Model 375XL

BFP-4 BACKFLOW PREVENTER PER ADDENDUM #2-1

Shop Drawing Submittal Review

Project Name: Webster University-**ISB**

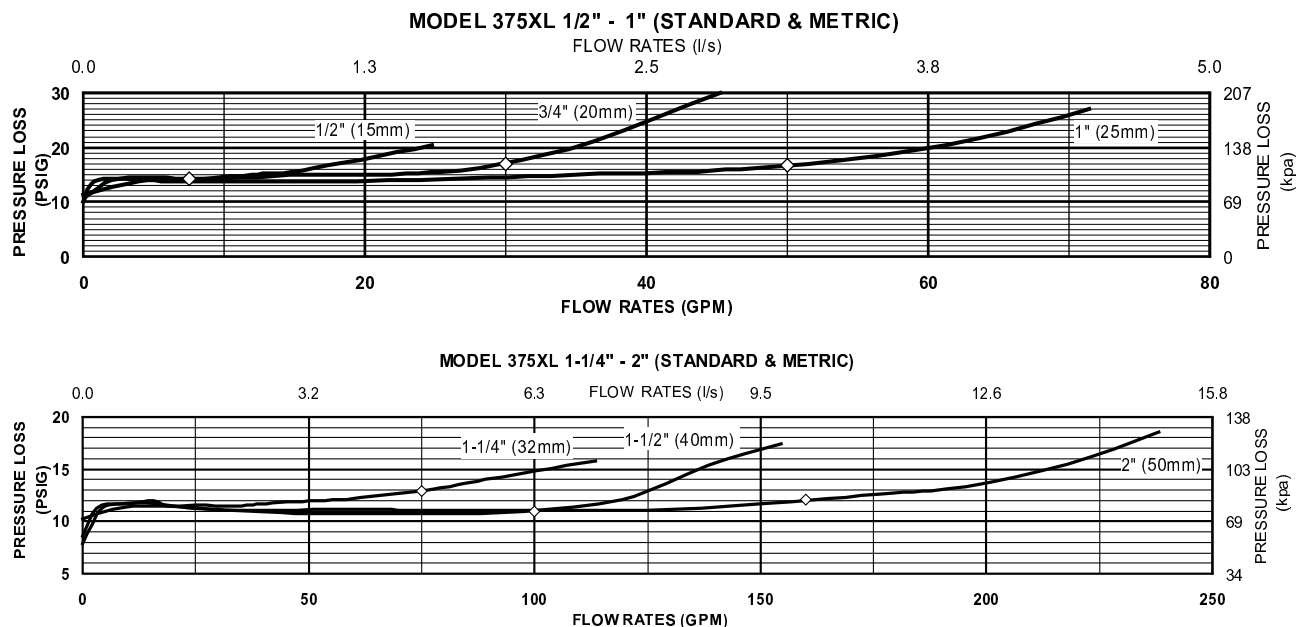
1. BFP-4 - Provide caps and tethers for each test cock.

X				BFP-4 Backflow Preventer Zurn Model – 375XLSH With Strainer	1. Provide caps and tethers for each test cock.
X					Air Gap Fitting Zurn Model – AG5	
		X			Trap Primer PPP Model – PR-500	1. This type/style of trap primer is not specified for this project. Is contractor proposing to use this type/style rather than the waste arm trap primer?
		X	X		Water Hammer Arrester Sioux Chief Model 650-660 Series	1. Provide type/style specified. Refer to specification section 22 1119. Part 2 Products, paragraph 2.12. 2. Refer to Plumbing Fixture Schedule on drawing P0601.
